Louisiana Energy Services, L.P.

(National Enrichment Facility)

Docket No. 70-3103-ML

**APPLICANT'S PREFILED TESTIMONY IN MANDATORY HEARING
CONCERNING MATTERS RELATED TO NUCLEAR CRITICALITY (SAFETY
MATTER NOS. 5 - 8 AND OCTOBER HEARING QUESTIONS 6.b, 6.e, 6.f, and 6.g)**

Figure 1 Mean Log Energy of Neutron Causing Fission versus H/U Ratio

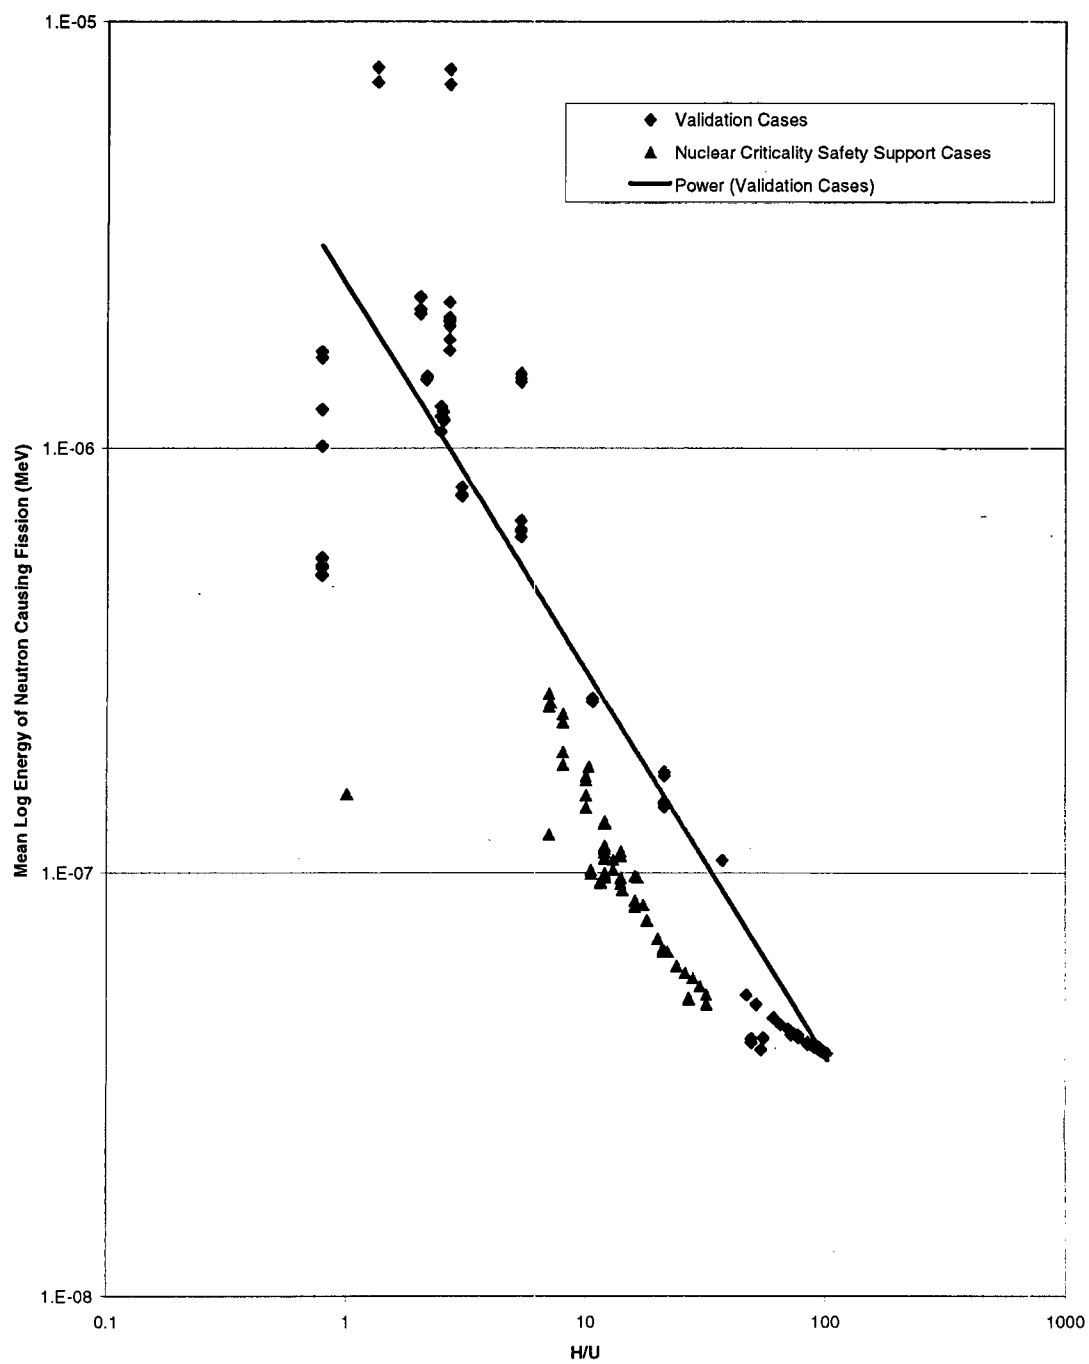
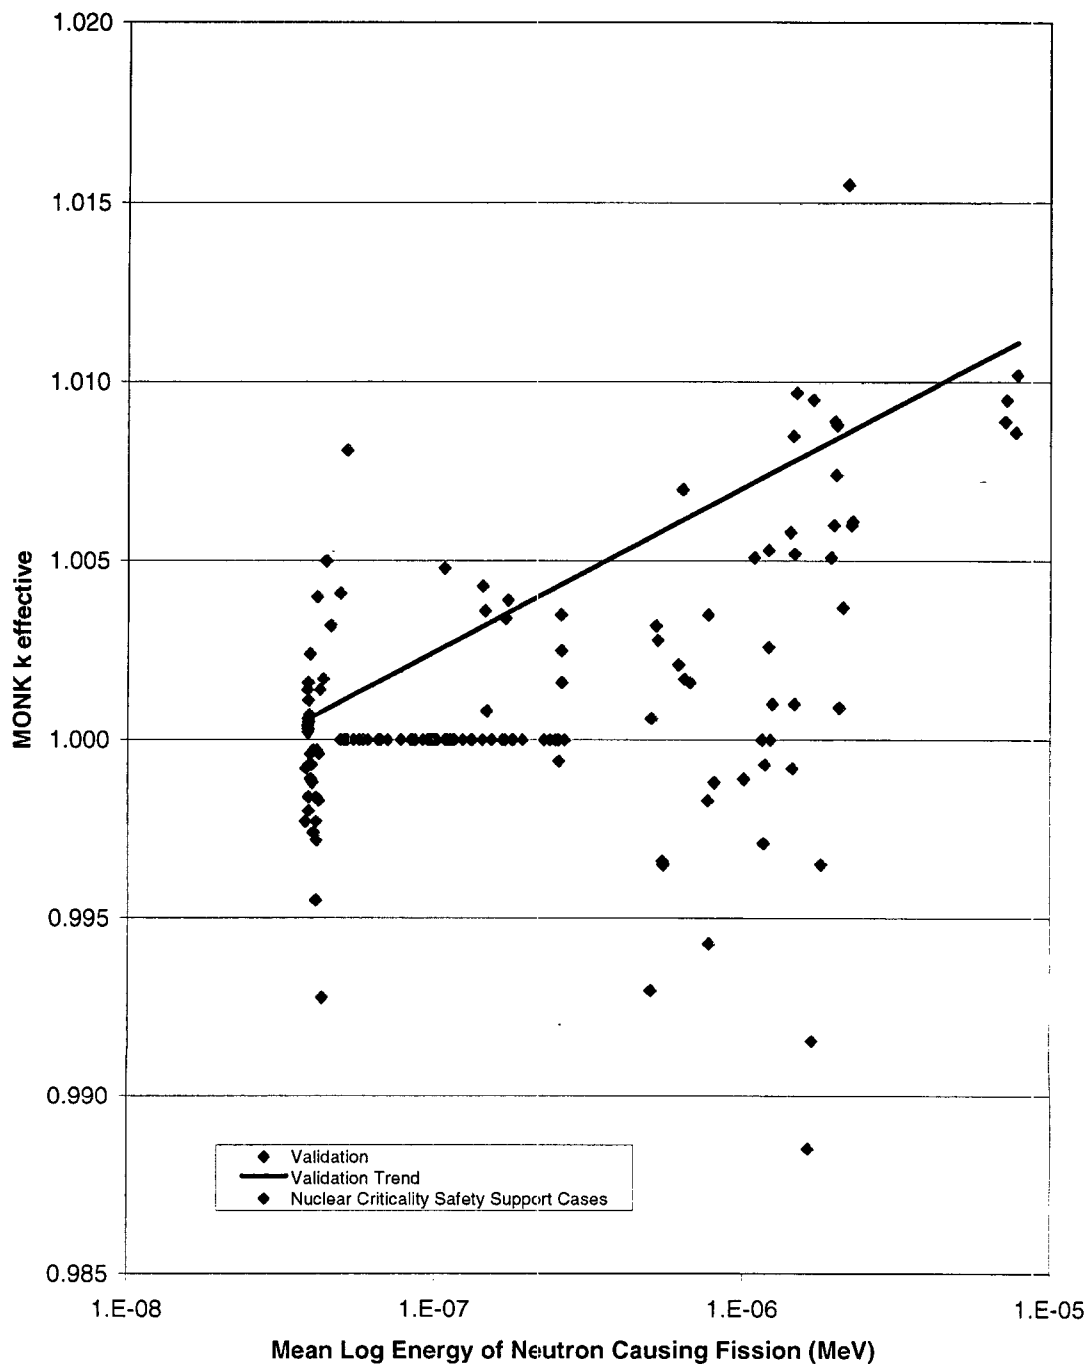
There are some gaps in the H/U ratios in the validation cases that may contribute to the calculated change in bias associated with variance of H/U ratio ranges. Given that the spectrum is primarily controlled by the H/U ratio, the impact of the variance of H/U ratio ranges

on the MONK 8A validation for NEF (*i.e.*, change in bias) can be answered by looking at how well the neutron energy spectrum is covered by the validation cases.

Figure 1 and Figure 2 ("Validation and NCS Support Analysis Cases k -effective vs Mean Log Energy of Neutrons Causing Fission") below show that the LMENCF for the NEF NCS support analyses cases cover a region of the plot that has some gaps in the validation cases. However, the NEF NCS support analyses cases all fall in an energy region below 1 eV. Neutron cross sections in this energy region vary very little with energy, and are usually well characterized by $1/v$ behavior. Given the well-behaved cross sections in this energy region, there is no reason to expect a change in bias due to a relatively small change in neutron spectrum. As a result, considering the strong correlation between H/U ratio and neutron energy spectrum, it is expected that the true impact (given sufficient applicable benchmark critical data) of the variance of H/U ratio ranges, for the ranges covered by the NEF NCS support calculation cases, should be insignificant.
